CITY PLAN COMMISSION**THURSDAY, MAY 2, 2024****FILE NUMBER:** S234-089**SENIOR PLANNER:** Sharmila Shrestha**LOCATION:** Akron Street, west of Guymon Street**DATE FILED:** April 3, 2024**ZONING:** TH-3(A)**CITY COUNCIL DISTRICT:** 6**SIZE OF REQUEST:** 0.482-acres**APPLICANT/OWNER:** WD Trinity, LLC

REQUEST: An application to create one 5,925-square foot lot, one 7,534-square foot lot, and one 7,554-square foot lot from a 0.482-acre tract of land in City Block 7238 on property located on Akron Street, west of Guymon Street.

PRELIMINARY PLAT
TRINITY AKRON ADDITION
LOTS 1-3, BLOCK 7238
HUNTER SURVEY, ABSTRACT NO. 608
OF DALLAS, DALLAS COUNTY, TEXAS

EXISTING AREA ANALYSIS MAP

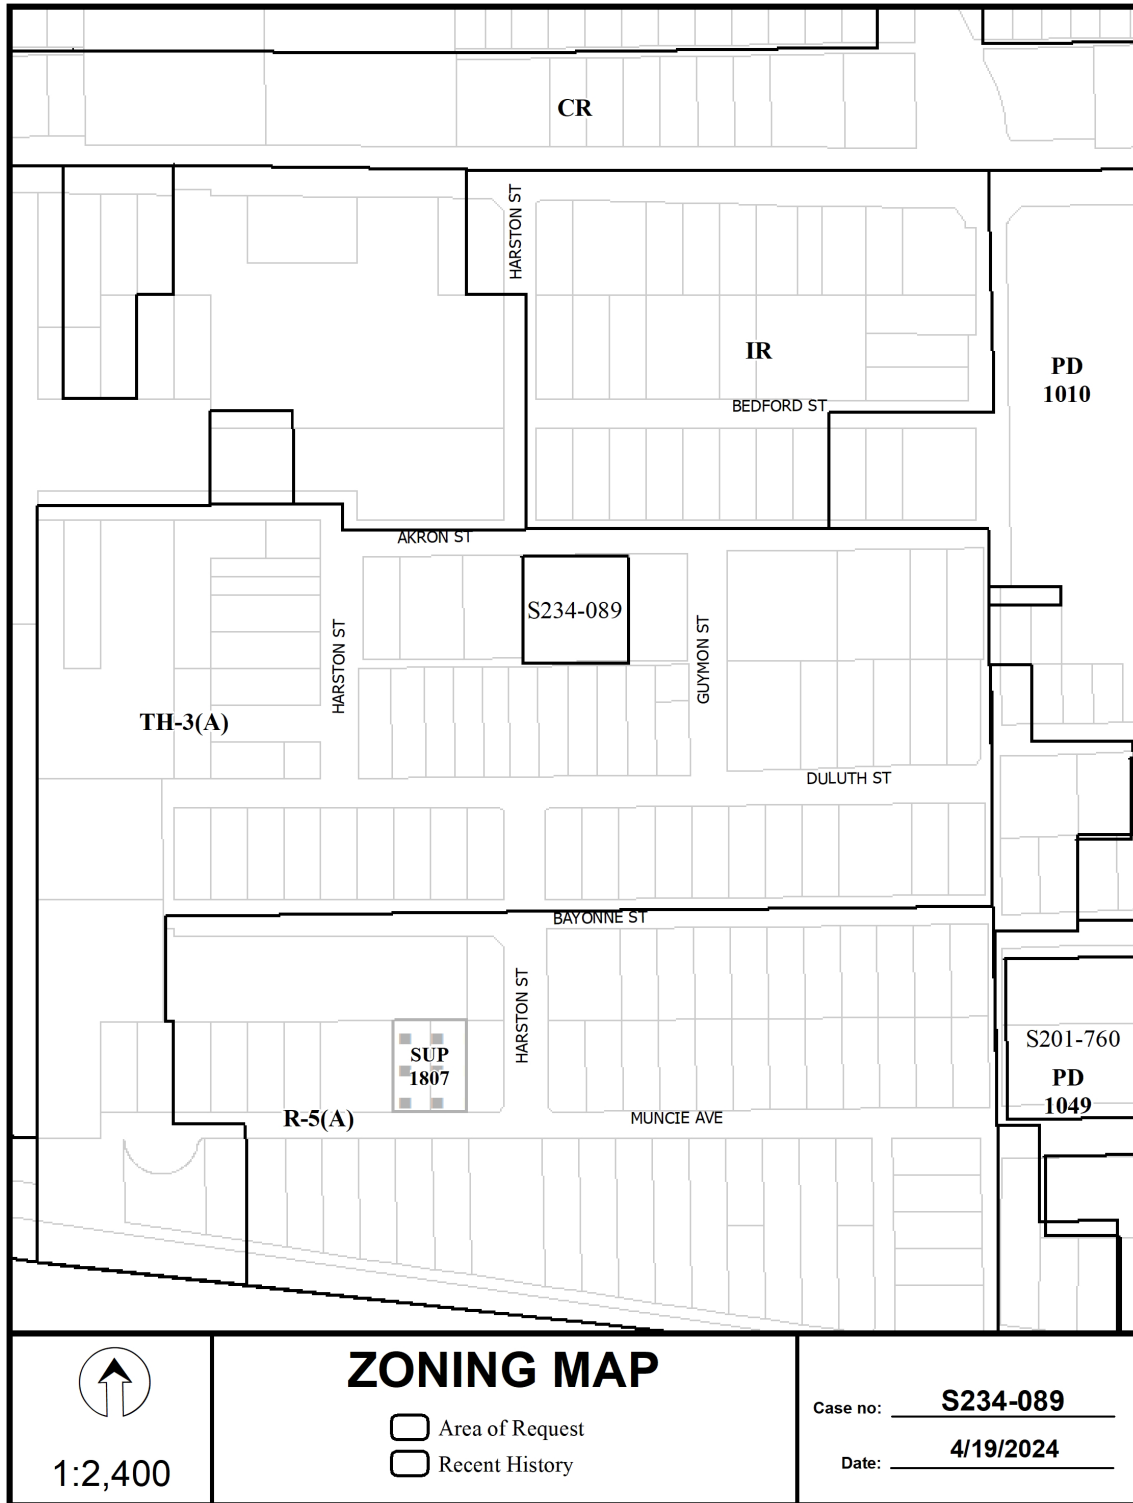
Staff finds that there is a variation in lot pattern in the adjacent areas (*Refer to the existing area analysis map*); and the request is in compliance with Section 51A-8.503 and also with the requirements of the TH-3(A) Townhouse District therefore, staff recommends approval subject to compliance with the following conditions:
